# Lal Lal Wind Farm - Elaine

Verification of Post-Construction Noise Assessment (Revised Report)

Issue | 13 November 2023

Job number 270849-00

Figure 1 K15aa baseline & criteria comparison

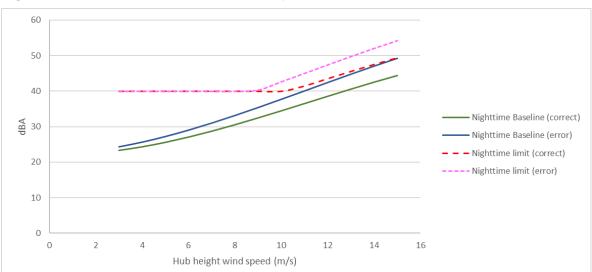
The inadvertent transcription error in which the third term was entered as positive instead of negative, has the effect of changing the baseline equation and hence the 'background + 5 dBA' portion of the night-time noise limit. The effect of the change is illustrated in **Figure 1**.

- Table 6 Compliance margin Night Only (K15aa row values) NCTP method
- Table 8 Compliance margin Night Only (K15aa row values) 0.5 dB method
- Table 7 & Table 8 the order in which H18aa, K15aa, and L18aa are presented was modified to be consistent with other tables.
- Section 11 Conclusion paragraphs 6 & 7 wording updated to reflect changed margins of compliance for K15aa night-time
- Appendix B NCTP method K15aa: Figure 8 K15aa compliance results night only
- Appendix B NCTP method K15aa: Table 14 K15aa compliance results night only
- Appendix C 0.5 dB method K15aa: Figure 20 K15aa compliance results night only
- Appendix C 0.5 dB method K15aa: Table 20 K15aa compliance results night only
